RE: Response to Wyoming Department of Environmental Quality's Review of Addendum #2 for the Section 109 Permit Application for Pioneer Wind Park I and Pioneer Wind Park II, dated April 12, 2011

To: Wyoming DEQ – Industrial Siting Division  
From: Pioneer Wind Park I, LLC and Pioneer Wind Park II, LLC  
Re: Changes to subsections of W.S. § 35-12-109 based on revised turbine layout  
Date: April 15, 2011

## **Summary of Changes to Pages within the Section 109 Permit Application for PWP I and PWP III due to revised Site Layout**

Figure 6-1R Results of Viewshed Analysis and KOP Locations, Pioneer Wind Park Project.

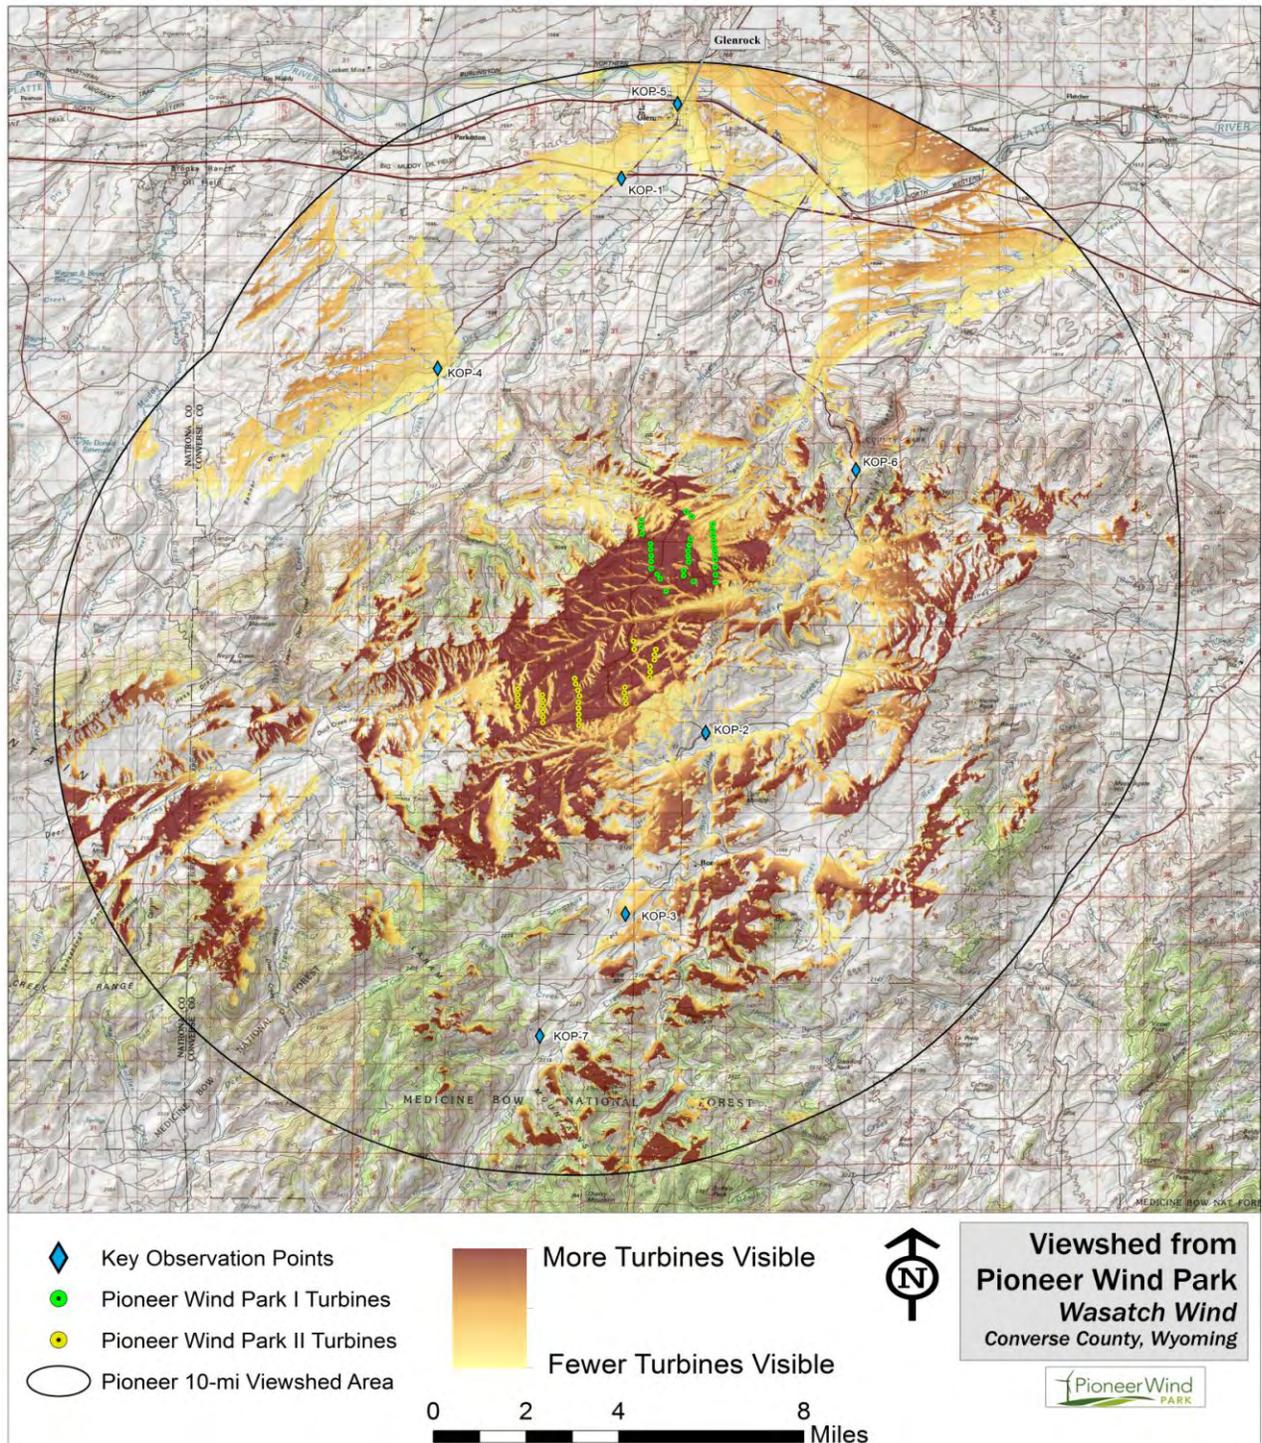
11. Page 6-61 - Figure 6-1 Results of the Viewshed Analysis and KOP Locations

- Replaced with revised figure showing results of viewshed analysis for revised turbine layout.

- Under the revised turbine layouts, the uppermost portions of only two wind turbines, rather than nine, would be visible from KOP 1 (Figure 6-3).
  - Within the 10-mile viewshed, no wind turbines would be visible from 72% of the area and, conversely, turbines or portions thereof would be visible from only 28% of the area.
